757

Service Bulletin

Number: 757-30-0019
Date: July 19, 2006
Revision 2: April 19, 2010
ATA System: 3041 5611

SUBJECT: ICE AND RAIN PROTECTION - Flight Compartment Window Anti-Icing - Windshield Inspection and Replacement

FIGURE 1: INSPECTION OF THE LEFT WINDSHIELD

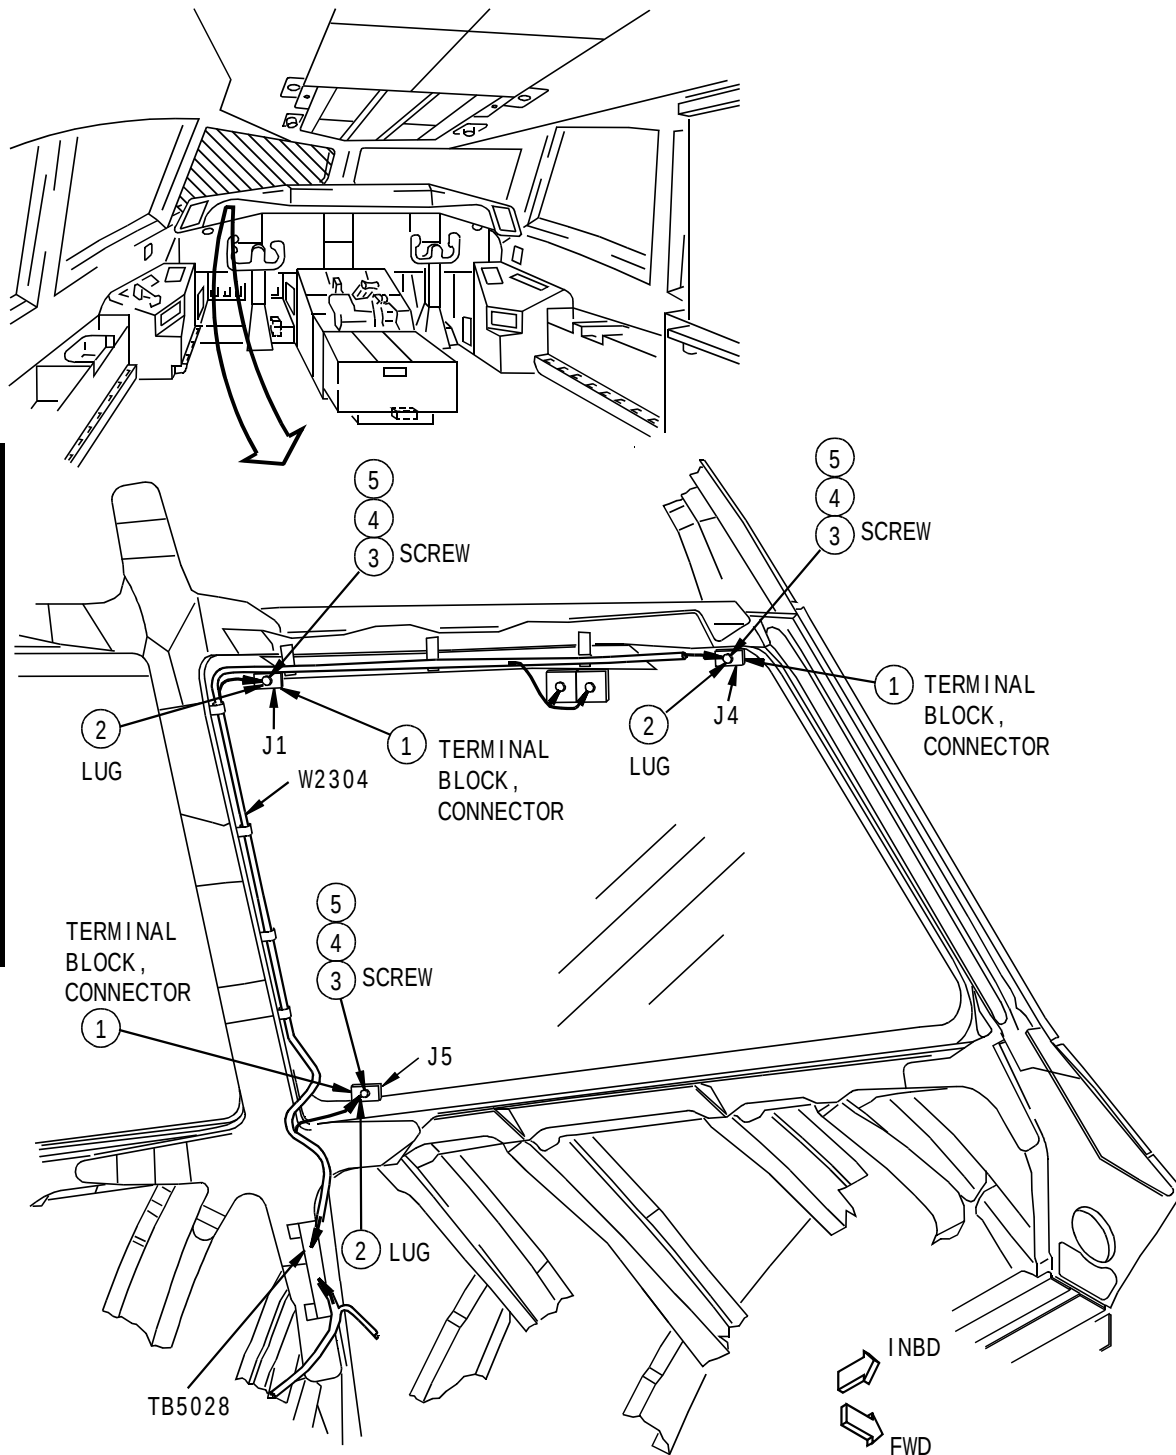
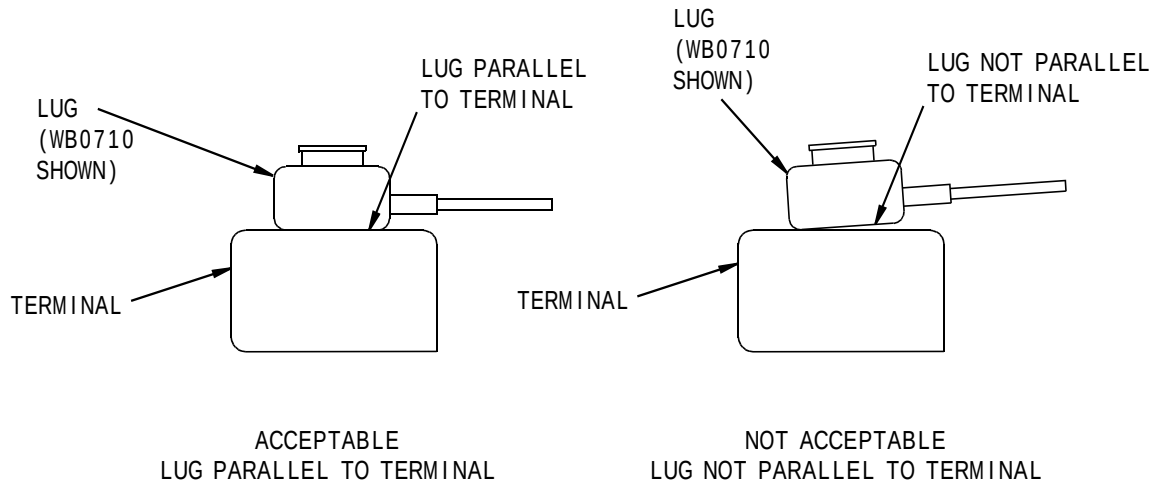
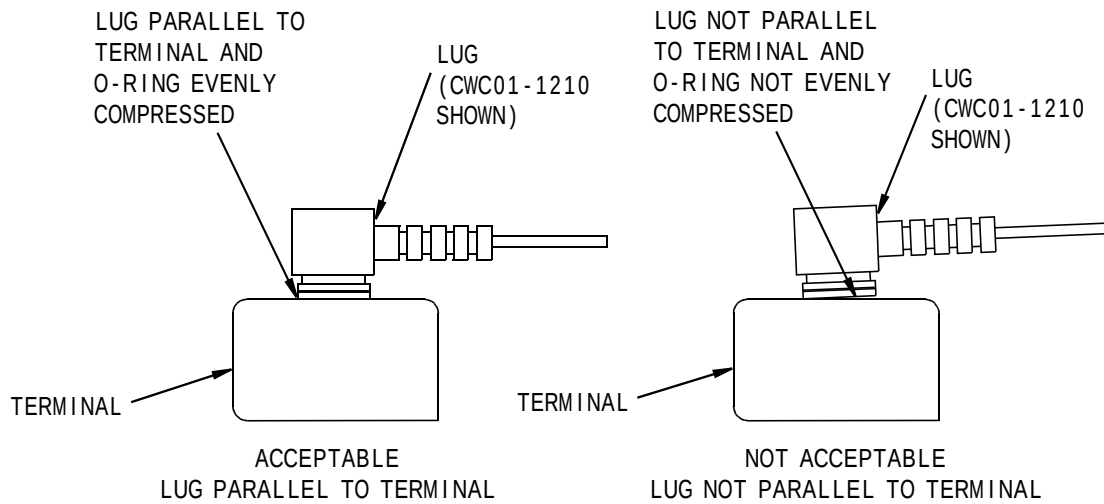
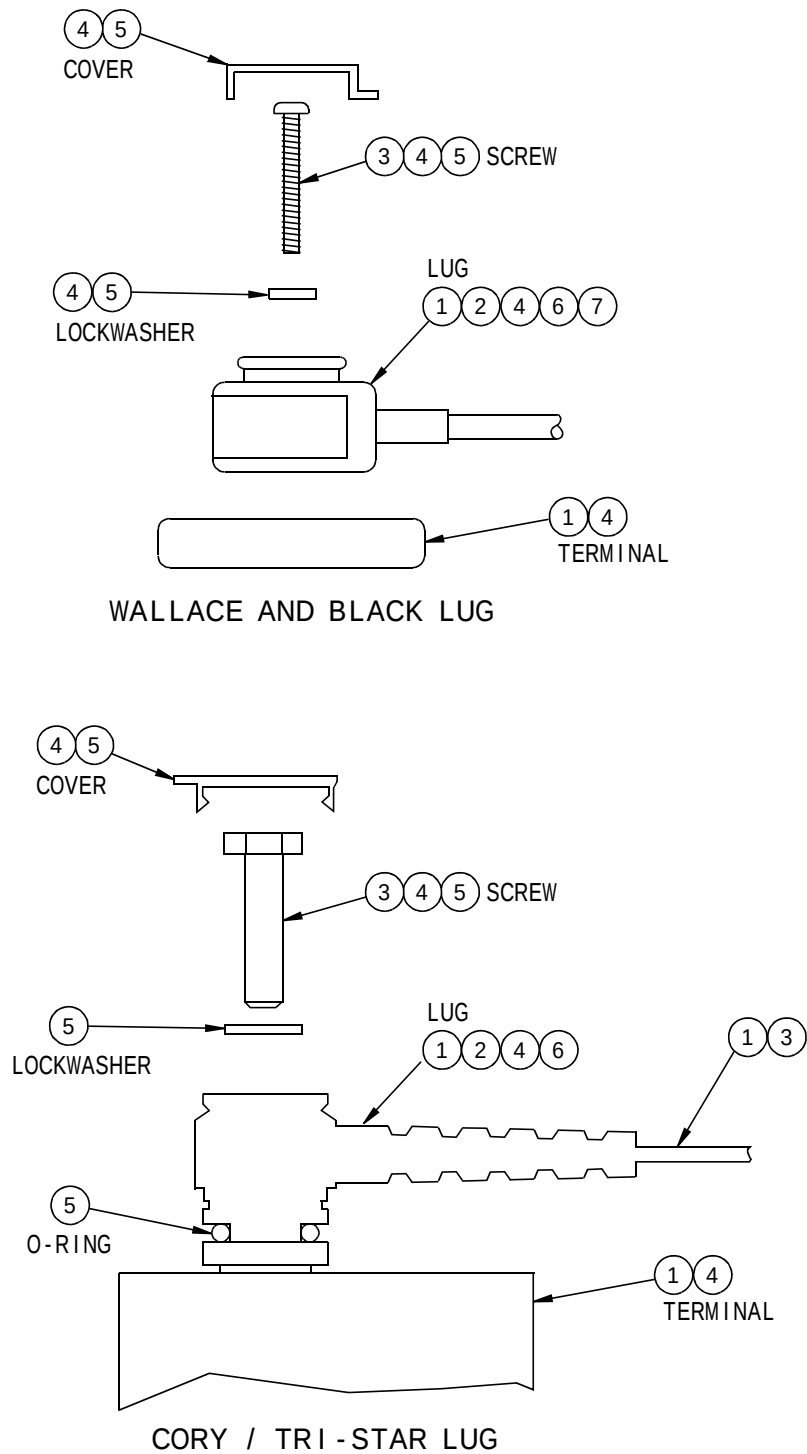
8. In the Work Instructions 3.B., step 3 of Work Packages 1 and 2 has been changed to add new compliance time thresholds for windshield inspections.
9. In Figure 1 and Figure 2 the illustration has been changed to add the inspection of the J1 and J4 lugs and terminals.

10. In Figure 1 and Figure 2 new illustrations have been added to show the installation of the lug and the correct alignment of the lug on the terminal.

11. In Figure 1 and Figure 2, step 2, the step table note has changed to show another cause of a loose terminal. The Standard Overhaul Practices Manual (SOPM) reference 20-43-03 has been changed to Standard Wiring Practices Manual (SWPM) reference 20-64-16 and Illustrated Parts Catalog (IPC) reference 30-41-52 has been added. New steps have been added to give instructions to inspect the screw if it cannot be tightened in step 3.

STEP	TASK	NAME	IDENTIFICATION	QTY	MORE DATA
1	Inspect	Terminal Block	J1, J4, J5	3	At the J1, J4 and J5 connections
		Lug	-	3	
		Wiring	Wire bundle W2304	3	
	NOTE: If the terminal lug or cap has melted, replace the shipside terminal lug and windshield.				
	NOTE: If the terminal block has melted, distorted or cracked, replace the windshield.				
NOTE: If the shipside wire insulation is melted or discolored, then repair or replace shipside wiring as necessary. Refer to Standard Wiring Practices Manual SWPM 20-10-13 as an accepted procedure.					
2	Inspect	Lug	-	3	To make sure it is a tight connection and not cross threaded.
	NOTE: If the terminal lug moves while applying light manual pressure to the strain-relief on the lug, then the screw that attaches it must be tightened. There are four causes for a loose terminal. 1-The screw is not tightened to the correct torque. 2-The terminal is damaged. 3-The incorrect screw is installed. The correct screw part number is given in SWPM 20-64-16 and Illustrated Parts Catalog 757 IPC 30-41-52. 4-The screw is cross threaded.

NOTE: If the lug is not parallel with the terminal, then the screw is cross threaded. Check for lug alignment, the lug and terminal must be viewed from the side. It may be necessary to view the lug and terminal from the exterior side of the window.				
	NOTE: If the lug shows signs of arcing, blueing, overheating or melting, replace the lug and windshield.				
	CAUTION: DO NOT OVER TIGHTEN. THE TERMINAL CAN BE DAMAGED BY TOO MUCH FORCE. A DAMAGED TERMINAL WILL REQUIRE THE REPLACEMENT OF THE WINDOW.				
3	Torque	Screw	-	3	To 25 to 30 inch pounds of torque. Refer to SWPM 20-64-16 as an accepted procedure.
	Inspect	Lug	-	3	To make sure the connection is tight.
	NOTE: The screw is only tightened if the lug is loose. If it is the correct screw and it cannot be tightened to 25 to 30 inch pounds, do steps 4 and 5.				
NOTE: If the cross threaded screw can not be tightened, replace the window.

STEP	TASK	NAME	IDENTIFICATION	QTY	MORE DATA
4	Remove/Keep	Cover	-	3	
	Remove	Screw	-	3	To make sure the correct screw is installed and there is no damage to terminal, lug or screw.
		Washer	-	3	
	Inspect	Terminal	J1, J4, J5	3	To make sure the terminal or lug is not damaged.
		Lug	-	3	
	NOTE: If the terminal block mating surface has contamination, clean surface. Refer to SWPM 20-20-00 Cleaning Method 5 as an accepted procedure. If the terminal shows signs of arcing, blueing or overheating, the window must be replaced.				
	NOTE: If the mating surface on the terminal lug has contamination, clean surface. Refer to SWPM 20-20-00 Cleaning Method 5 as an accepted procedure. If the lug cannot be cleaned or shows signs of arcing, blueing or overheating, the lug must be replaced.				
	CAUTION: DO NOT OVER TIGHTEN. THE TERMINAL CAN BE DAMAGED BY TOO MUCH FORCE. A DAMAGED TERMINAL WILL REQUIRE THE REPLACEMENT OF THE WINDOW.

5	Install (New)	Screw	-	3	To make sure lug is assembled to terminal with new, undamaged and correct hardware.
		Washer	-	3	
		O-ring	-	3	
	NOTE: Reassemble the lug to the terminal with a new screw, lock washer and o-ring. Make sure the o-ring is installed prior to assemble of the lug to the terminal. A new o-ring is only available for the CWC01-1210 lug. Refer to SWPM 20-64-16 and 757 IPC 30-41-52 for the correct screw, washer and o-ring.				
	NOTE: Make sure the screw has been aligned correctly.				
	Torque	Screw	-	3	To 25 to 30 inch pounds of torque. Refer to SWPM 20-64-16 as an accepted procedure.
	Install/Kept	Cover	-	3	
NOTE: Do step 2 to make sure the screw has been installed correctly and is a tight connection.					
6	Inspect	Lug	-	3	Apply light manual pressure to strain-relief on lug.
	NOTE: If the lug moves with light manual pressure, replace the windshield.

FIGURE 4: CHANGES TO THE WIRING FOR THE WINDOW HEAT ON THE LEFT WINDSHIELD

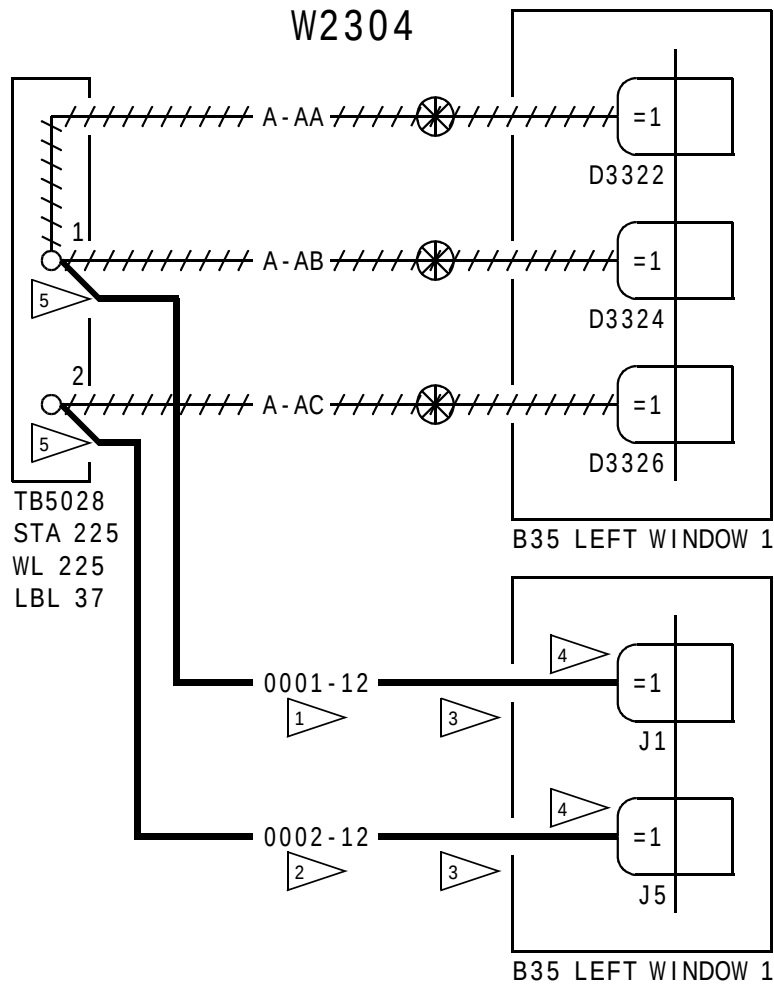
2. Remove the left windshield. Use the windshield handling sling, A56001-2. Refer to 757 AMM 56-11-01 as an accepted procedure.
3. Cut the bulb seal for the left windshield as given in Figure 3.
4. Change the wiring for the window heat on the left windshield as given in Figure 4 and Figure 5.
5. Install the left windshield. Use the windshield handling sling, A56001-2. Refer to 757 AMM 56-11-01 as an accepted procedure. At the operator's choice, use one of the windshields shown below:

FIGURE 6: CUT THE BULB SEAL FOR THE RIGHT WINDSHIELD

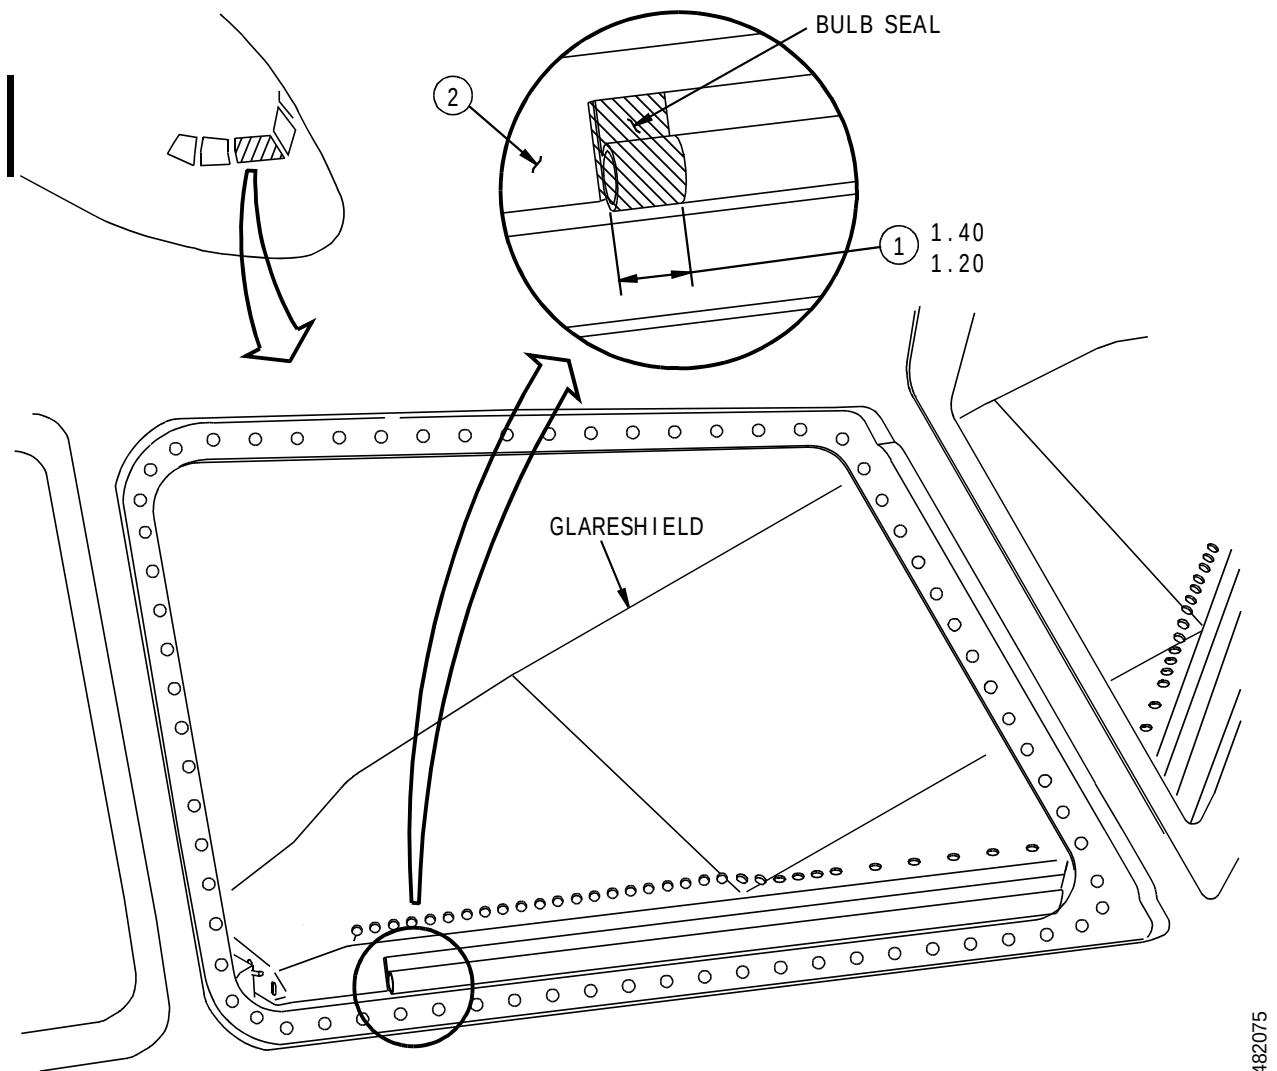
12. Figure 6, in the illustration, circle note 2 has been moved to point to an area near the bulb seal. This is the area where the part mark can be applied.

STEP	TASK	NAME	IDENTIFICATION	QTY	MORE DATA
CAUTION: DO NOT CUT THE STRUCTURE BELOW THE BULB SEAL. THE WINDOW SILL IS A HIGH MOISTURE AREA AND MOISTURE CAN CAUSE CORROSION IF THE FINISH IS DAMAGED. DAMAGE TO THE FINISH MUST BE REPAIRED.					
1	Cut	Bulb Seal	233T8300-8	-	to clear the new terminal.
	NOTE: If the finish below the bulb seal is damaged, it will need to be sealed with chemical treatment and primer. Refer to Standard Overhaul Practices Manual SOPM 20-41-02 and 20-43-03 as accepted procedures.				
2	Identify	Glareshield		-	(a)
(a) Part Mark with service bulletin number before new windshield is installed. Refer to SOPM 20-50-10 as an accepted procedure.

FIGURE 7: CHANGES TO THE WIRING FOR THE WINDOW HEAT ON THE RIGHT WINDSHIELD

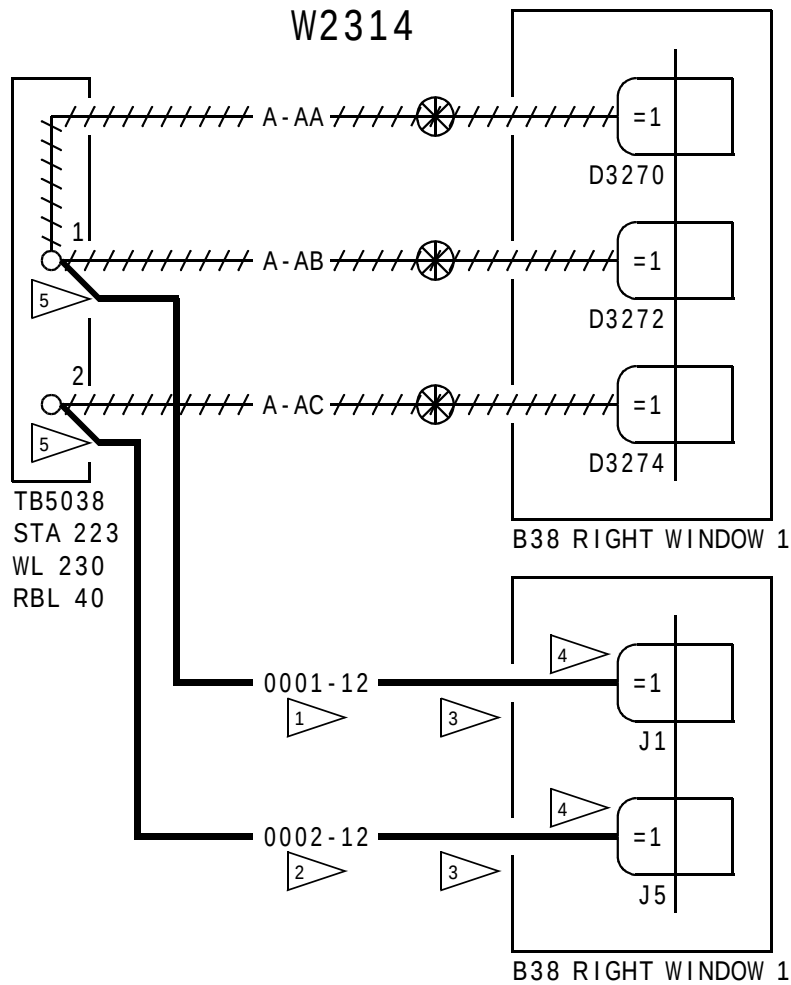
2. Remove the right windshield. Use the windshield handling sling, A56001-2. Refer to 757 AMM 56-11-01 as an accepted procedure.
3. Cut the bulb seal for the right windshield as given in Figure 6.
4. Change the window heat wiring for the right windshield as given in Figures 7 and Figure 8.
5. Install the right windshield. Use the windshield handling sling, A56001-2. Refer to 757 AMM 56-11-01 as an accepted procedure. At the operator's choice, use one of the windshields shown below:
